**MAJOR PROJECT ASSESSMENT:
*Mixed Use Development Eastlakes Shopping
Centre, Eastlakes*
(MP09_0146)**

Director-General's
Environmental Assessment Report
Section 75I of the
Environmental Planning and Assessment Act 1979

June 2013

Figure 21: East elevation of northern site showing two large unbroken sections of wall which would benefit from improved articulation to reduce the appearance of visual bulk.

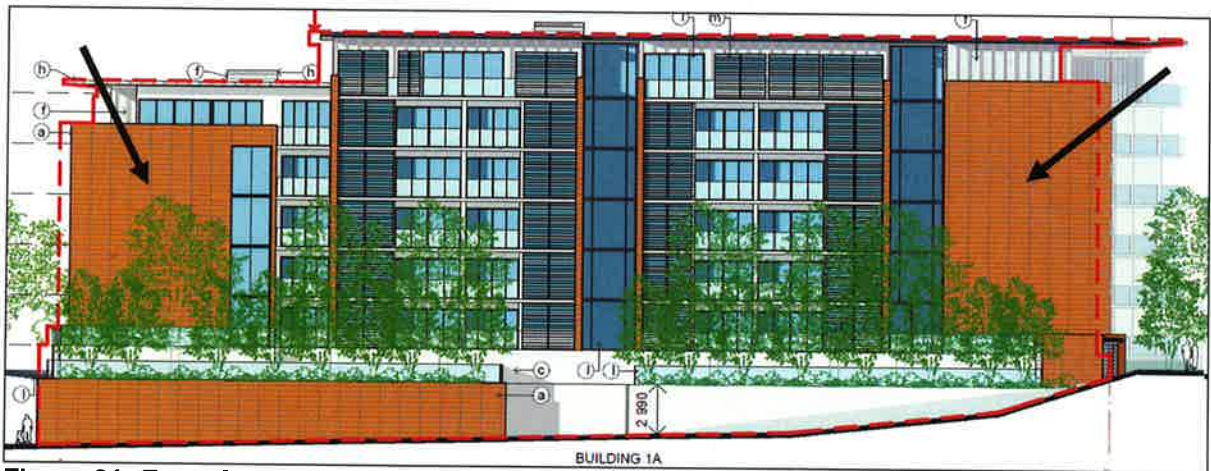
The Department considers that there are two additional sections of unbroken wall which would benefit from additional façade treatment or articulation to massing. The two walls are located on the east elevation of the northern site, which face adjoining residential premises and are also highly visible from the streetscapes of Evans Avenue and Gardeners Road (**Figure 21**). Provision of additional openings and facade articulation would reduce the

appearance of visual bulk of these walls which would in turn provide a better relationship with the scale and form of adjoining residential premises to the east. A condition is recommended requiring modified plans to this effect.

Figure 31: Building separation distances at the shown first floor level.

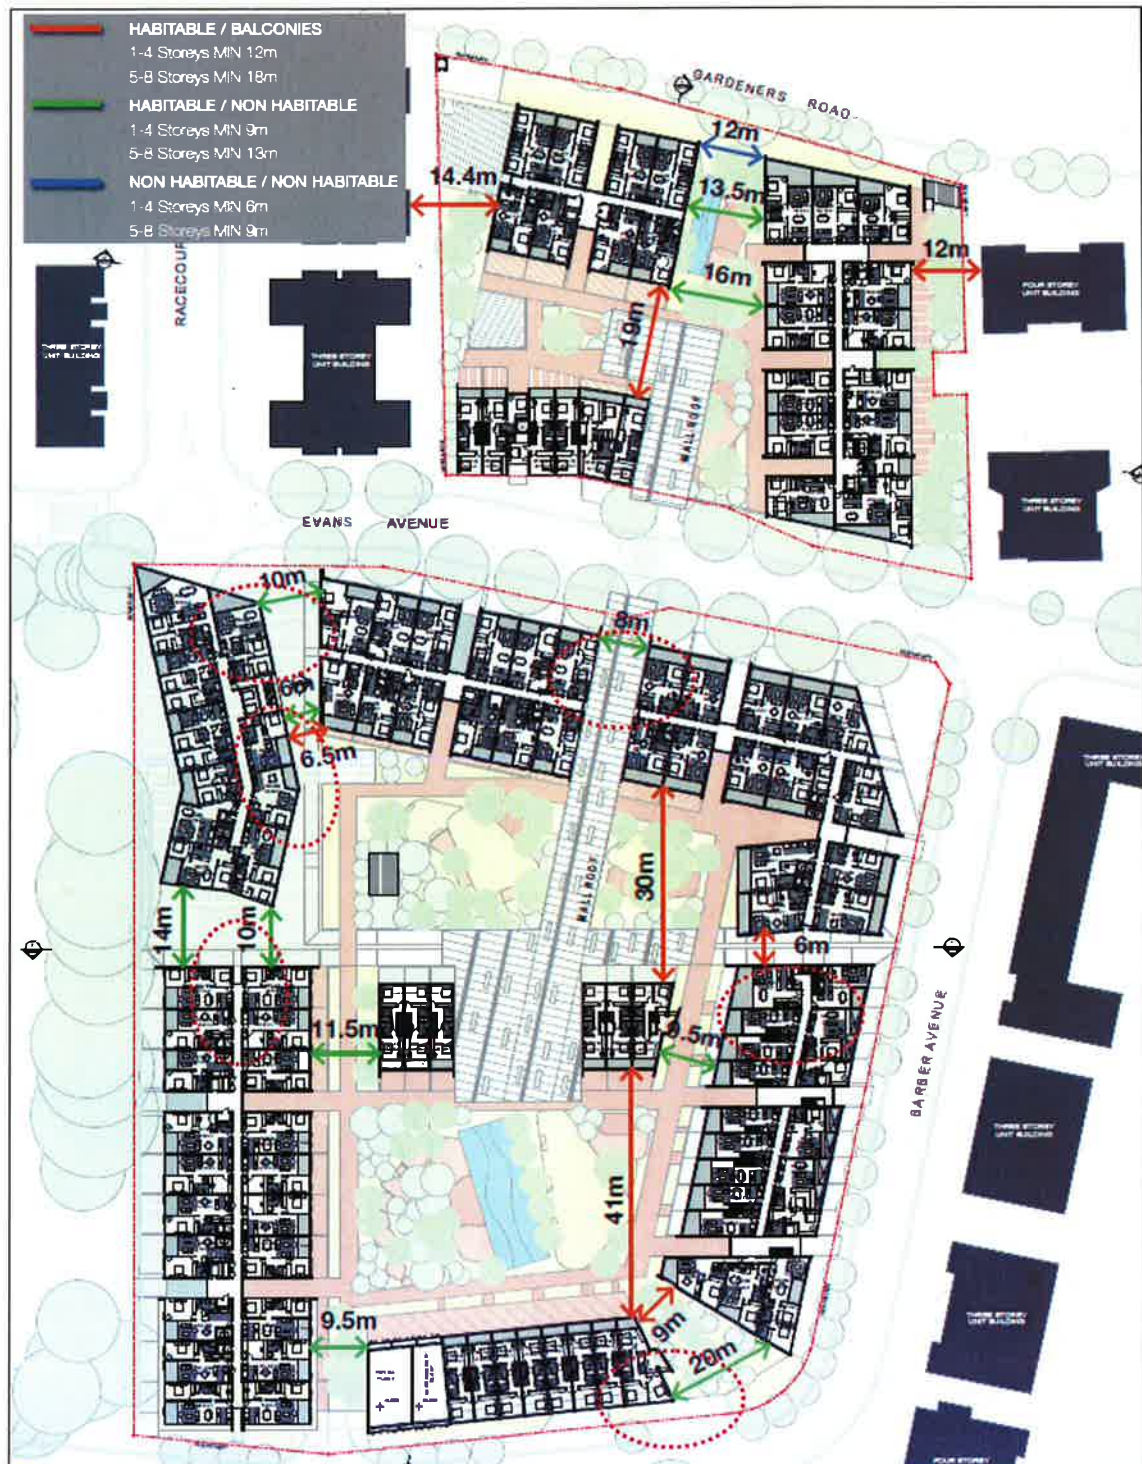
The proposed building envelopes generally provide for a range of building separation distances as demonstrated in **Figure 31**.

(dashed line) Non-complying setbacks.

Figure 32: Exit vehicle sight lines (shown in red) and pedestrian route around vehicle entrance (shown in blue).

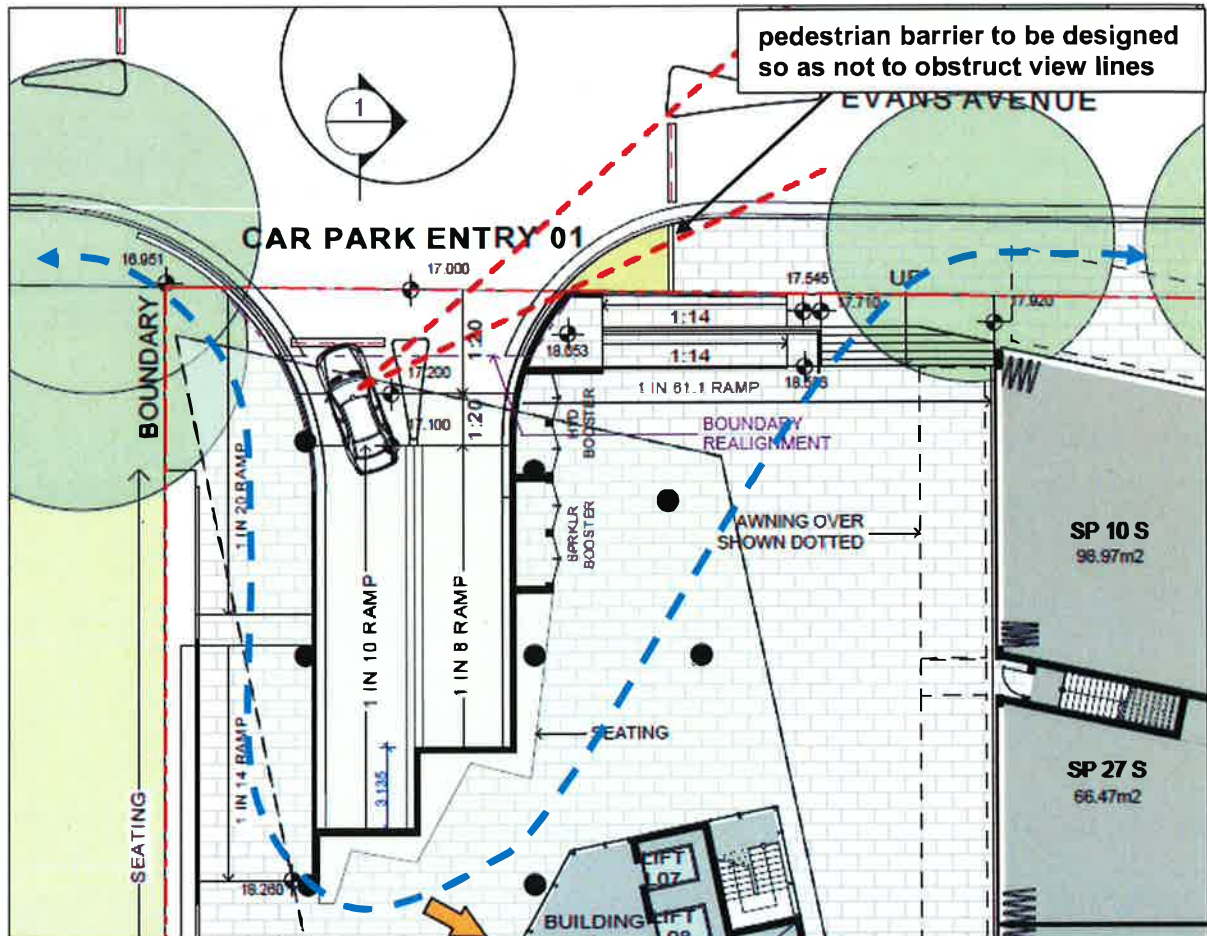
Ramp grades and sight lines for vehicles exiting the site at the Evans Avenue/Racecourse Place roundabout have also been analysed in detail and are considered to be satisfactory, with the imposition of a condition ensuring a proposed pedestrian fence does not obscure view lines (refer to **Figure 32**).

Safety in terms of pedestrian access routes were also considered. A key area of concern relates to the main vehicle entry point at the Evans Avenue/Racecourse Place roundabout. To address these concerns, the proposal has been designed to encourage pedestrians to travel around the entrance ramp and through the 'market square' rather than across the intersection. Barriers to discourage pedestrians from entering the intersection are proposed, and vehicle ramp gradients have been maximised to reduce the length of the pedestrian route (refer to **Figure 32**).

As the proposal essentially prohibits pedestrians from accessing the current footpath area and involves traversing the site, a condition is recommended requiring the provision of an easement or public right of way over the market square area.

Figure 33: Architects sketch of potential future development at 16 Evans Avenue

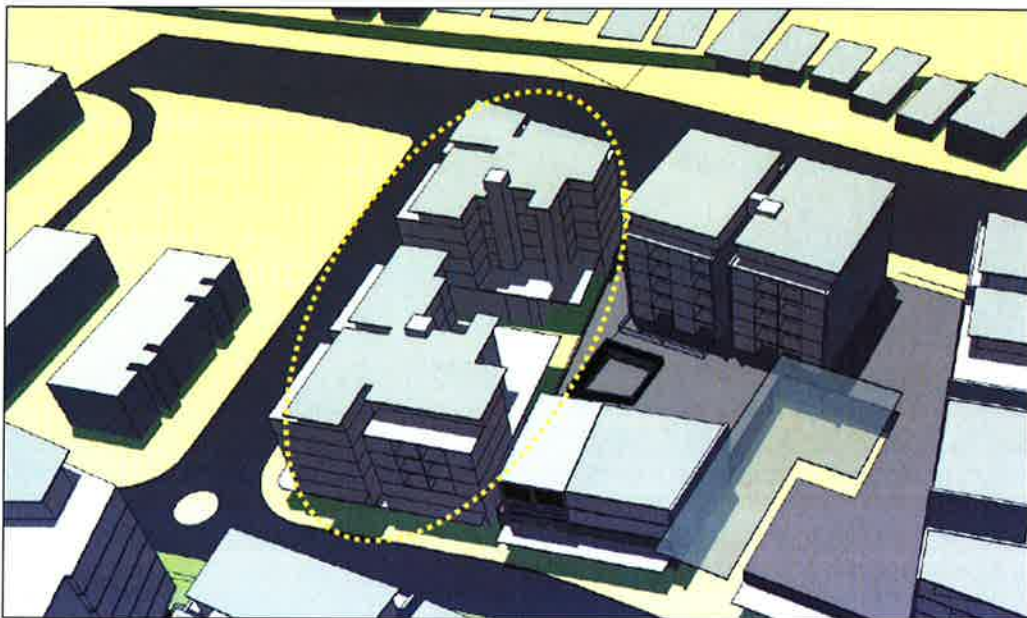
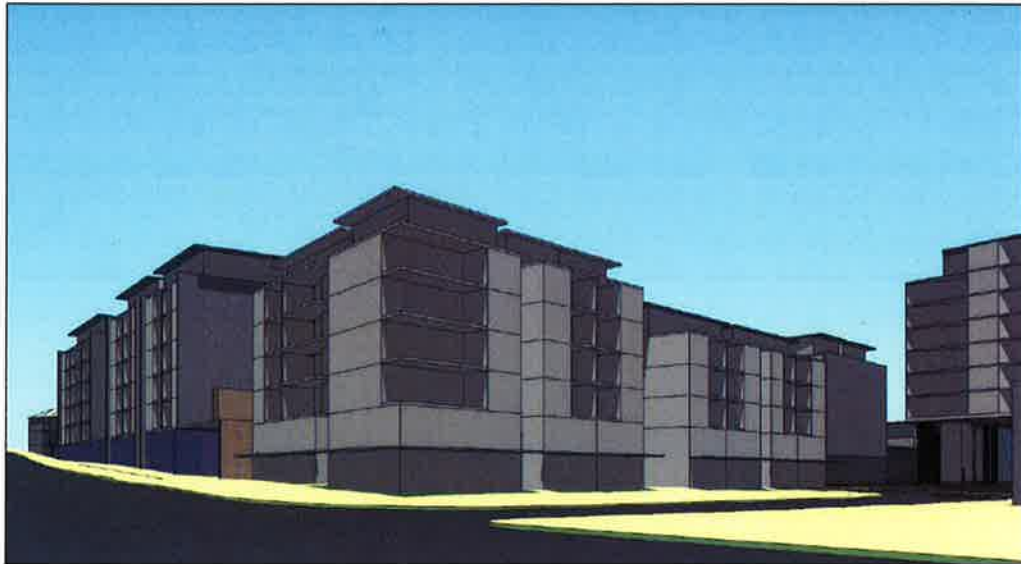
The proponent advises that they believe that 16 Evans Avenue is large enough (2,580m²) to be redeveloped independently of the proposed development. Sketch plans (**Figures 33 and 34**) of one possible built form layout submitted by the proponent indicate it may be capable of achieving 1,150m² of retail floor space at ground floor podium level; 4-5 levels of residential development providing 39 units (2 and 4 bedrooms); and basement car parking for 62 vehicles.

Council has questioned the accuracy and feasibility of the sketch plans and is concerned that they result in a building height and floor space ratio that would not comply with the draft Botany Local Environmental Plan 2012 controls and that no information to demonstrate the economic feasibility of the scheme has been provided.

Figure 35: Part of Gardeners Road elevation showing location of proposed signage and possible relocation of wall sign.

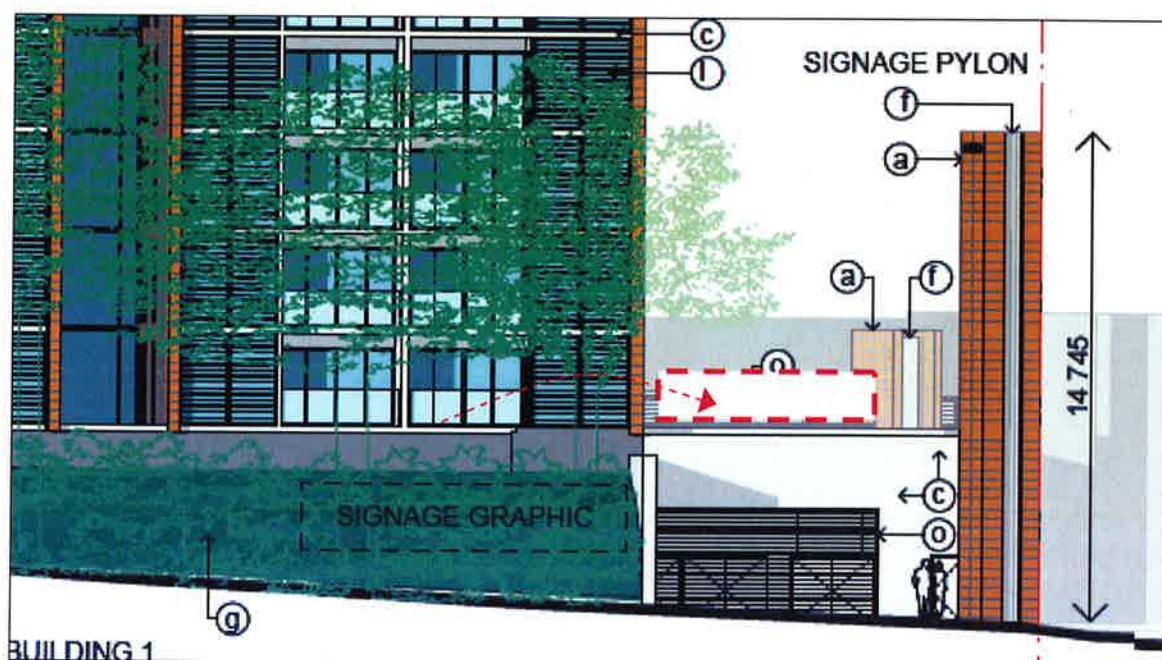
Four large signs are subject to assessment under the provisions of State Environmental Planning Policy No. 64. Refer to discussion in **Appendix D**. Two of the signs present lifestyle images and are essentially decoration, rather than advertising. They are oriented towards the market square / plaza rather than to the public domain. Subject to a condition ensuring illumination of the signs does not result in amenity impacts to adjoining residential premises, the signs are unlikely to result in any material adverse impacts. The other two signs are to be located on the western end of the Gardeners Road frontage and include a 14.75m high x 2.4m wide pylon sign in the street setback and a 9.5m wide wall sign facing Gardeners Road as can be seen in **Figure 35**.

The plans indicate that the illuminated wall sign on Gardeners Road would be located within the landscaped setback area, but it is unclear which wall it would be located on. It is not considered possible to provide a visible wall sign in this location without interfering with the proposed setback landscaping and the signage would be inconsistent with the character of this section of the streetscape building which presents only residential development to the street. The sign could be located in the podium wall just to the west of the landscaped area as indicated on the plan below, without adverse impacts to the character, streetscape or landscaping. It may also make a small contribution to activating this section of street frontage which is considered to have some safety issues as discussed below. A condition is therefore included in the recommendation.

The proposed pylon sign is 2.4 metres wide and obstructs pedestrian views in this area, which is essentially a recessed dead street frontage (it includes access to substation and plant area only). The sign also would result in overbearing visual impacts at the pedestrian level. While the overall height and scale of the sign is considered to be acceptable as the main marker for the Eastlakes Town Centre entrance, the Department considers that amendments should be made at the pedestrian level to allow for a more visually open base which permits pedestrians to view through the 2.4 metre wide sign to improve pedestrian amenity and safety.
